1. October 26, 2016 Agenda

## TOWN OF EAST HAMPTON

**RE:** Dittmer Subwaiver  
SCTM#300-136-6-1.1, 2.1, 4, 5

**"DITTMER SUBWAIVER"**

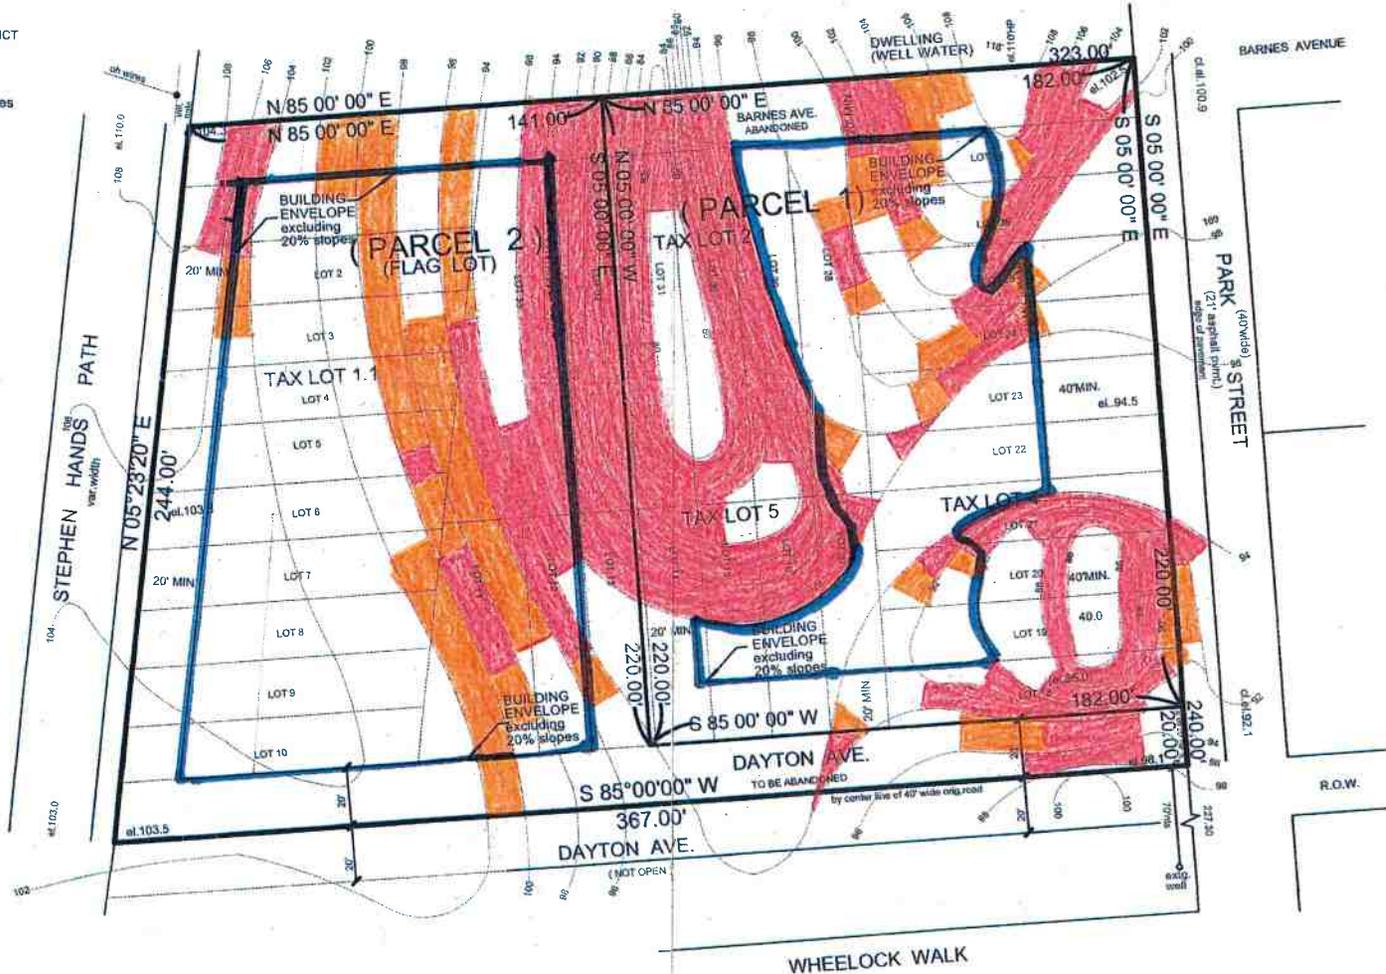
The building envelopes depicted on the map, do not exclude all areas with 20%. The Planning Department has utilized the map submitted and identified the 20% and greater slopes in red and the 15-20% slopes in orange on the attached sketch. The proposed building envelopes are outlined in blue. This sketch shows that the building envelopes include a number of areas with slopes of 20% and greater. Areas where slopes are 15% to 20% combined with the areas of 20% and greater represent sides of hills or depressions.

Additionally, the building envelope on Parcel 1 is very irregular in shape. Irregularly shaped lines as depicted are difficult to discern in the field and are more likely to be forgotten and disregarded over time. For this reason, it has been the Board's policy that building envelopes be regular in shape. The Planning Department recommends that the building envelopes be squared off to a more regular shape and that the areas of 20% or greater slopes be excluded.

The building envelope on Parcel 2 depicts a front yard setback of 20' and needs to be revised to provide the minimum front yard setback of 40'. Even though Parcel 2 is connected to Park Street by a 20' wide strip of land it has frontage on Stephen Hands Path, and is not classified as a flag lot under the Town Code and therefore not entitled to the lesser 20' along Stephen Hands Path. This increase in setback requirements along Stephen Hands Path will further reduce the available building envelope.

A revised map that identifies the 15-20% and 20% and greater slopes with revised building envelopes that respect the 40' front yard setbacks and exclude areas with 20% slopes should be submitted. The applicant needs to demonstrate that two lots with viable building envelopes can be accomplished.

Red - Slopes 20%+  
Orange - Slopes 15-20%  
Blue - proposed building envelope
